**Agenda Item 10**  
**Report PC21/22-11**

Report to	<b>Planning Committee</b>
Date	<b>9 September 2021</b>
By	<b>Director of Planning</b>
Title of Report	<b>Response to Rampion Extension Development Ltd's Section 42 Statutory Consultation on the Rampion 2 Offshore Wind Farm</b>
Purpose of Report	<b>To update Planning Committee on the SDNPA's draft Rampion 2 consultation response</b>

**Rampion Offshore Wind Farm  
Statutory Consultation – 14 July to 16 September 2021  
Section 42(1) (b) of the Planning Act 2008 and Regulation 13 of the Infrastructure  
Planning (Environmental Impact Assessment) Regulations 2017**

# Rampion 2 Sussex HLC, Field Patterns and onshore proposed route

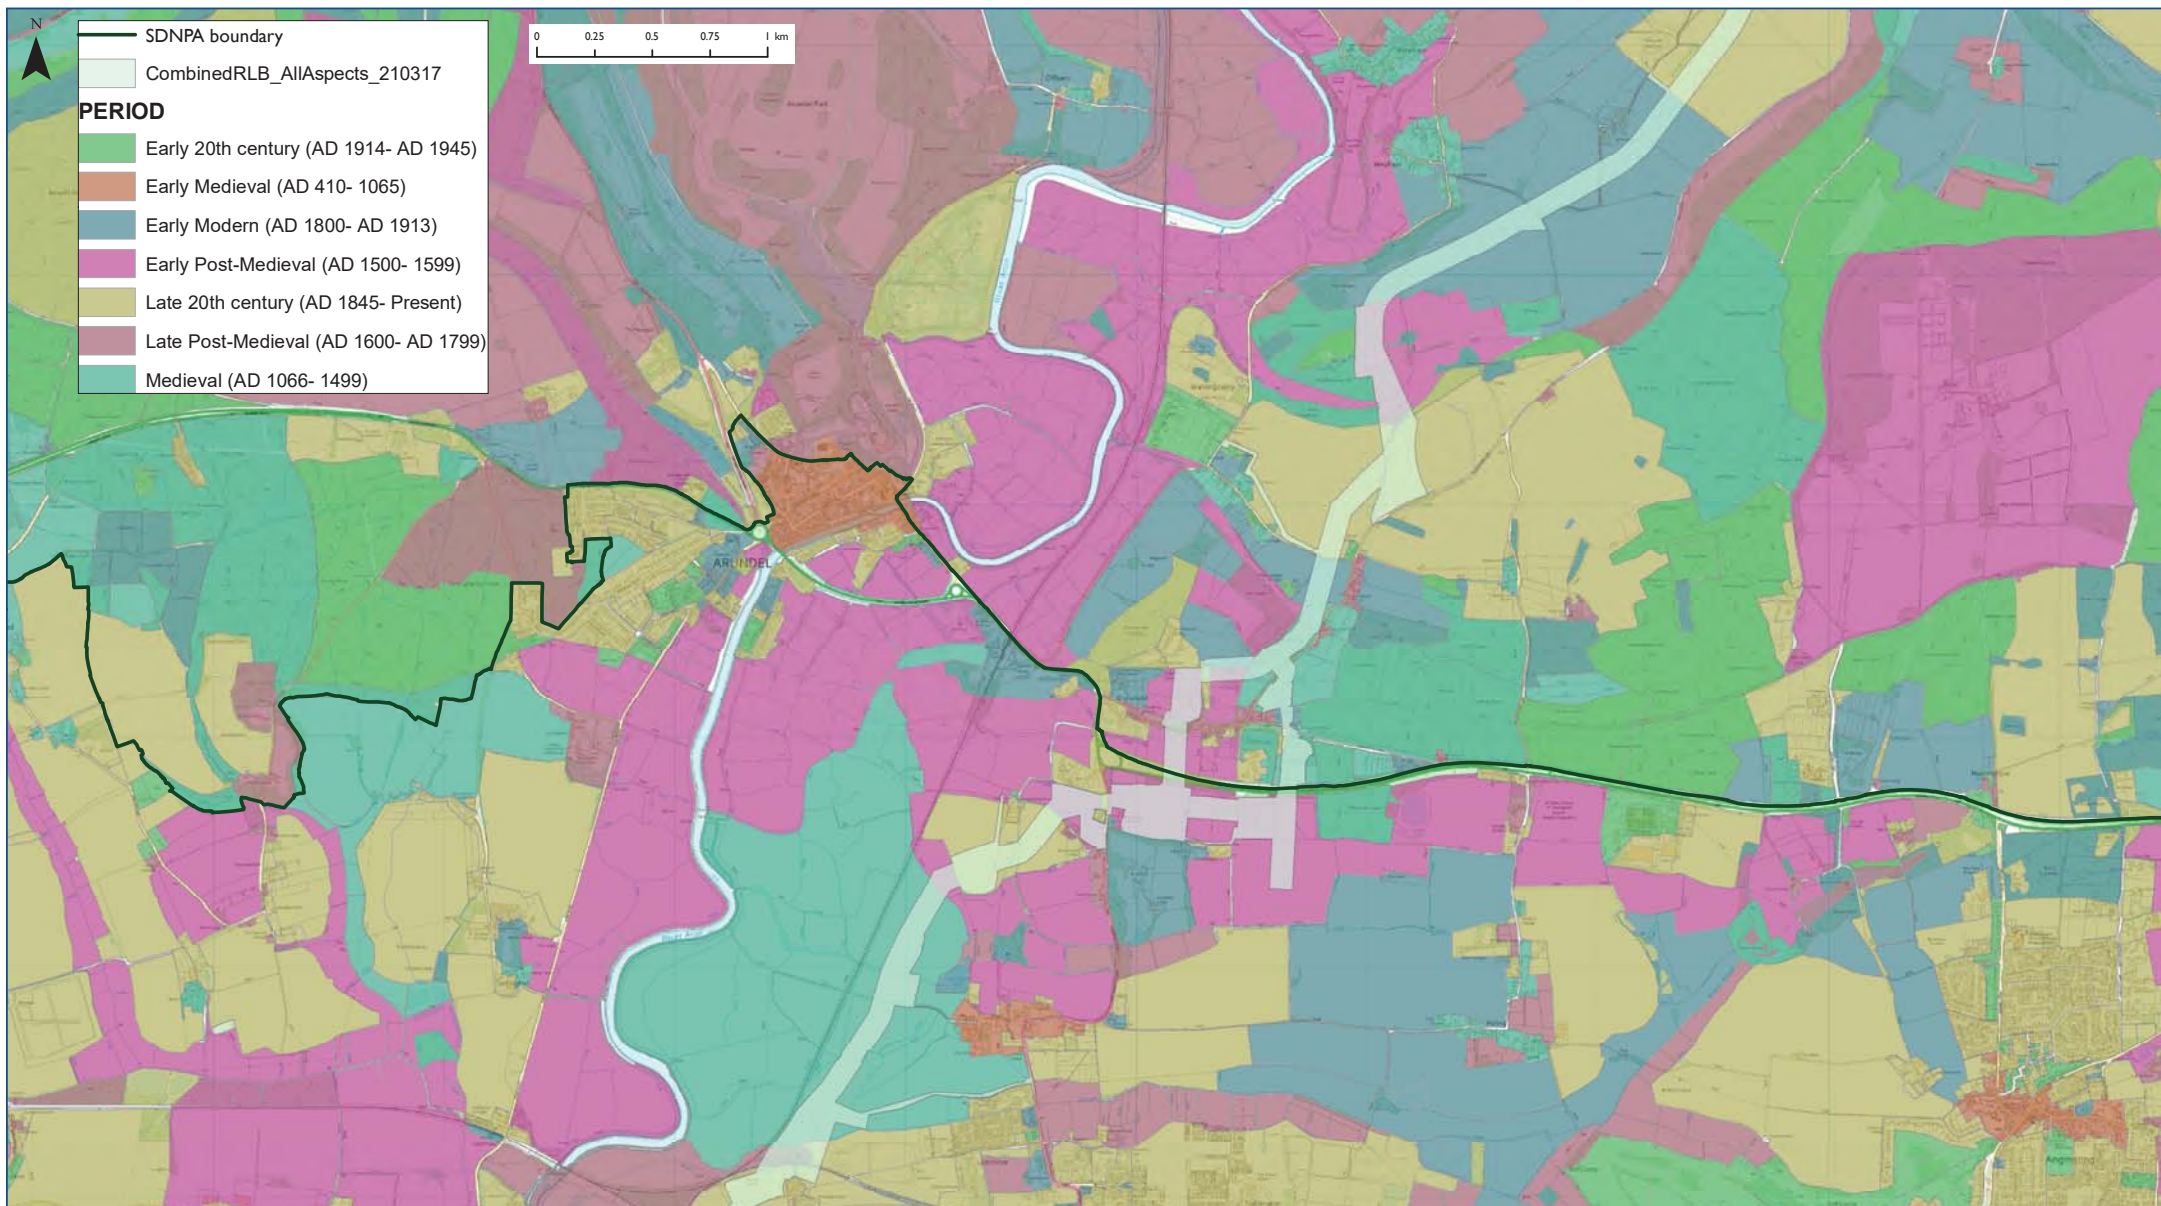
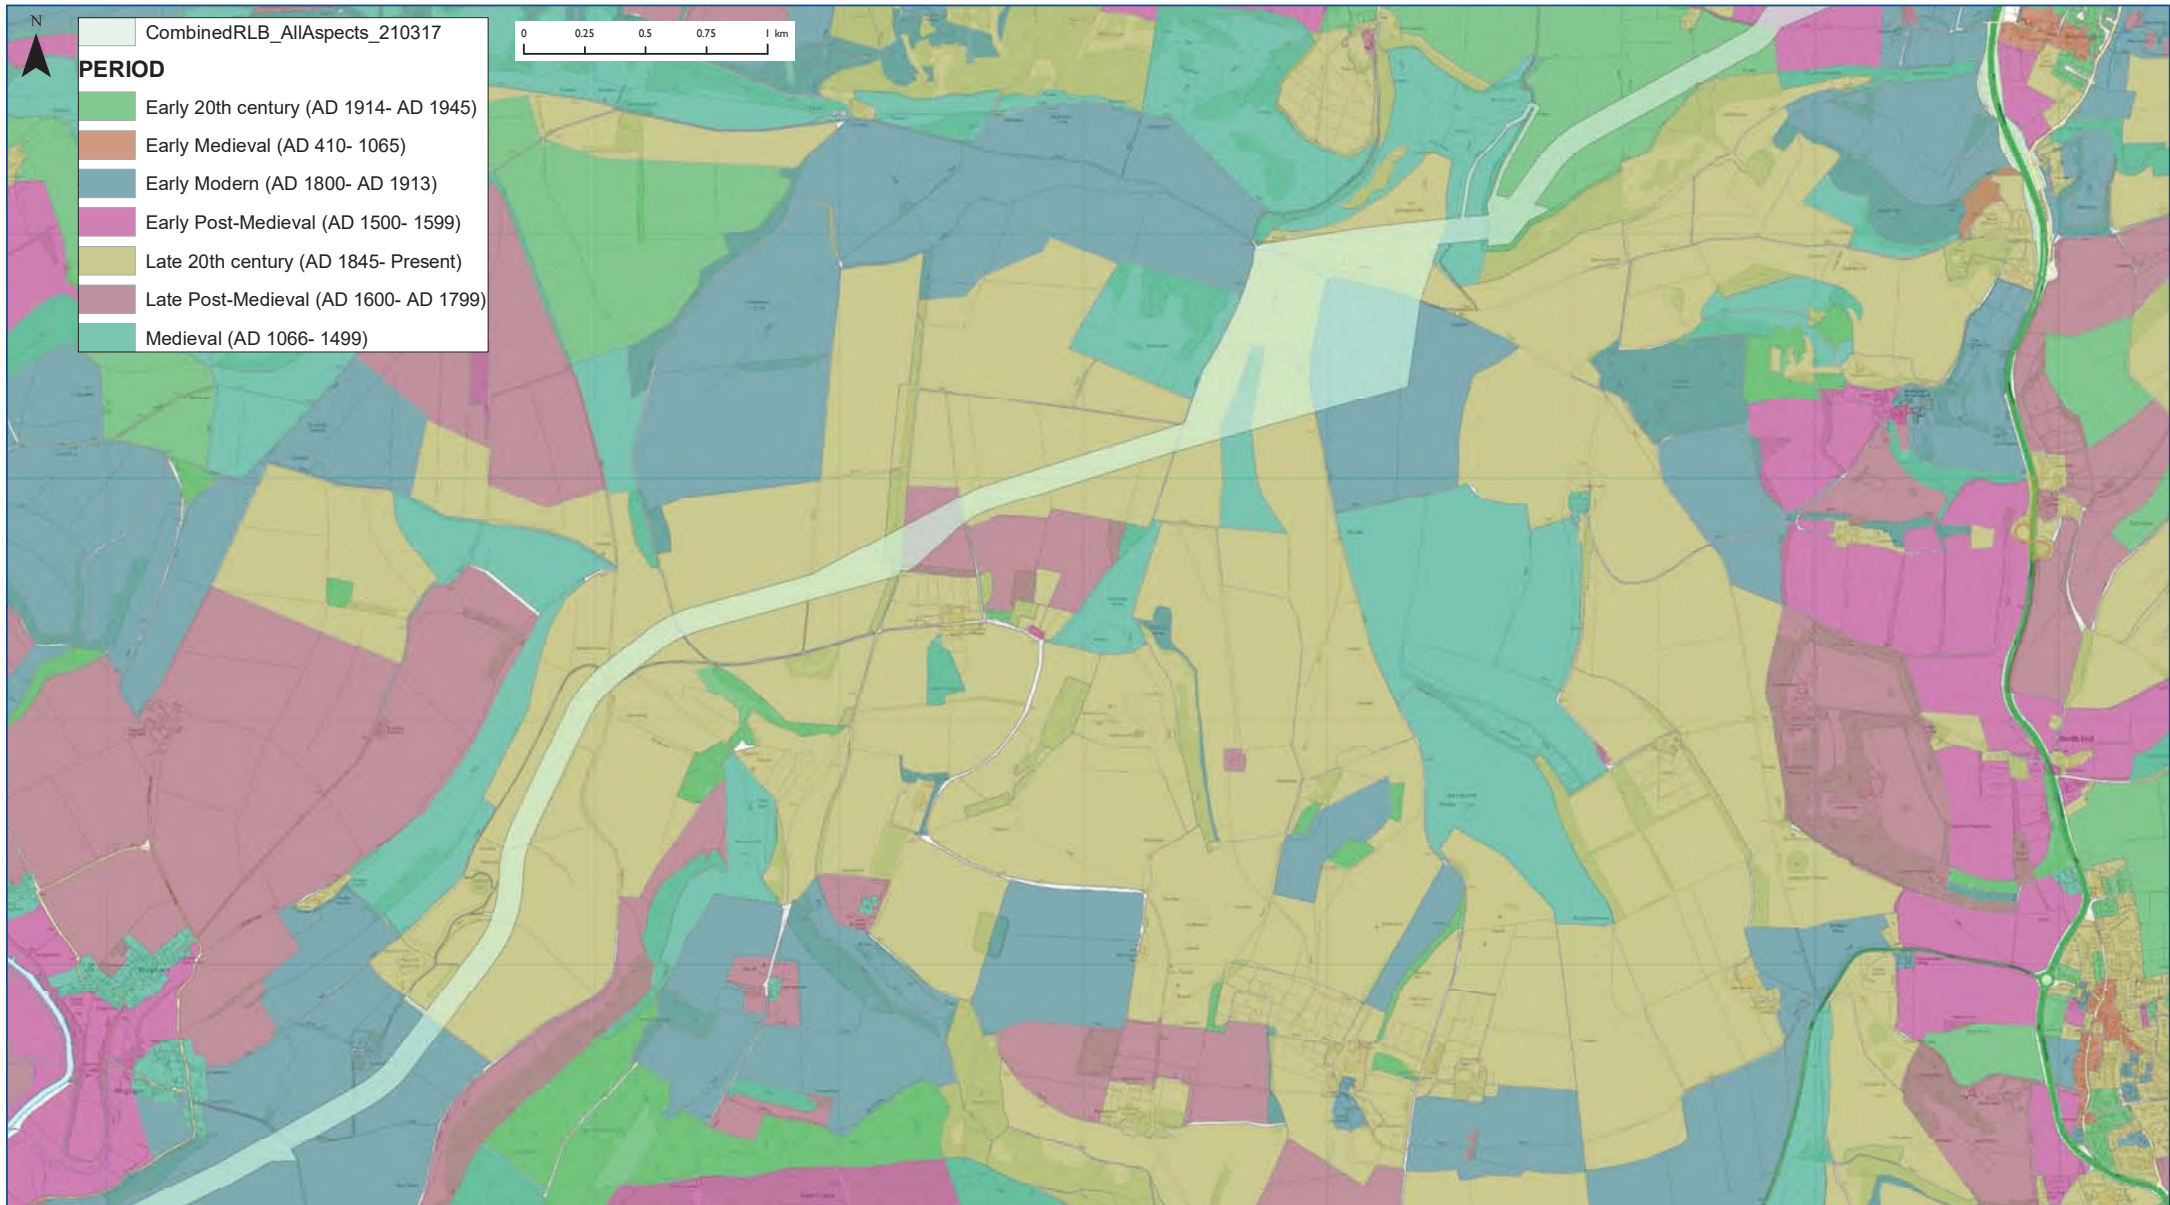
The assessment of Middle Arun Valley Floor LCA No. 34 has not taken account of the importance of the historic landscape features. **Appendix 4** includes excerpts of the Sussex Historic Landscape Character maps, which show the Middle Arun Valley floor as a clearly discernible feature crossed by the proposed cable route. The valley floor is a network of medieval floodplain grazing dating from AD1066 where individual fields are enclosed by 'wet hedges' – ditches. These systems are called 'Brooks Innings' in Sussex and there are only 2 areas where they exist – in the Arun valley and at Pevensey Levels. This feature is contiguous with the valley floor within the SDNP and has significant landscape cultural and ecological importance as part of the continuous landscape setting beyond the SDNP. We recommend re-evaluation of the setting of the SDNP and the context and features of the Arun valley.
